ADDENDUM NO. 03

Date: June 4, 2024

Project: Conway Corporation
Roger Q Mills Jr.
Water Treatment Plant 8 MGD Expansion & Improvements

The Contract Documents dated May 3, 2024, and Addendum No. 02 issued May 28, 2024, are hereby amended as follows:

HIGH SERVICE PUMP STATION HVAC SECTION AND ISOMETRIC

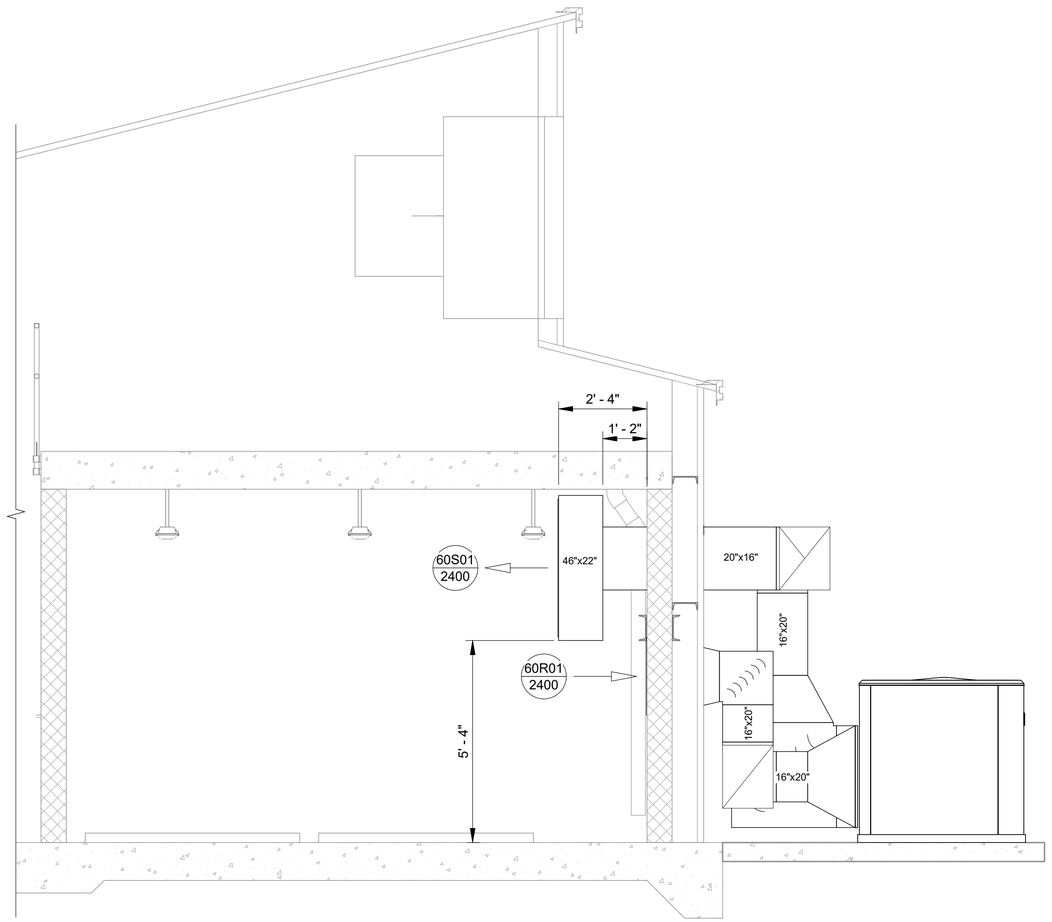
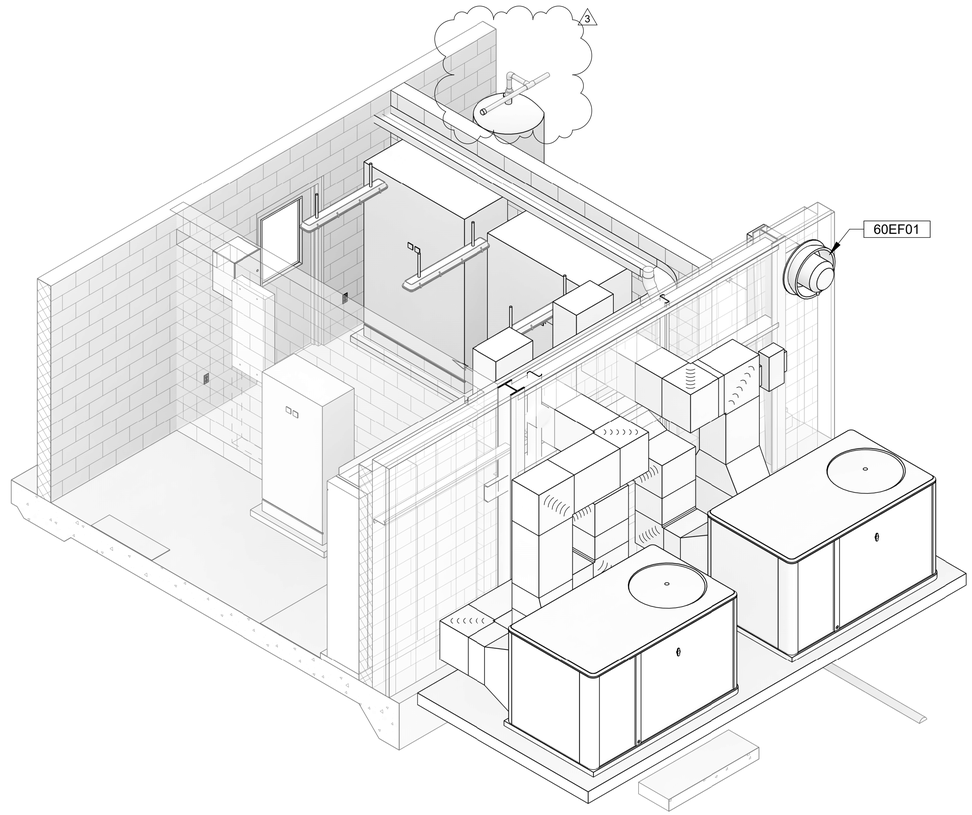
18. Drawing No. 60-M302 (Sheet No. 218)
    a. Add callout pointing to HVAC concrete pad:
    “STANDARD DETAIL D03/3000-1000, TYPE F”

23	What concrete detail should the HVAC pad be on sheet 210? A/Sheet 027? Something reinforcing?	Tolm Group (BR)	Use Standard Detail D03/3000-1000, Type F. See Addendum No. 3
24	What is going on with the access at the Southeast corner of the lime & pac building? Transitioning from South to North? Concrete stairs, Misc.Metal? Fence gate needed. Sheet 308	Tolm Group (BR)	Pending for Addendum No. 03
25	Is the Material Testing allowance intended to cover the costs of the crack injection testing spec 036400, 3.5, C/?	Tolm Group (BR)	Pending for Addendum No. 03
26	Is the Maintenance of Concrete Specification 030100 intended to be applied at any existing concrete locations? I see this specification if referenced in 033000, 3.5, M. As the patching requirement. I wasn't sure if there was any existing concrete surfaces or structures that were being rehabilitated via that specification.	Tolm Group (BR)	Currently, there are no areas known to require patching. However, there are areas of the existing plant that will be uncovered during construction that may require patching. This spec is provided for reference
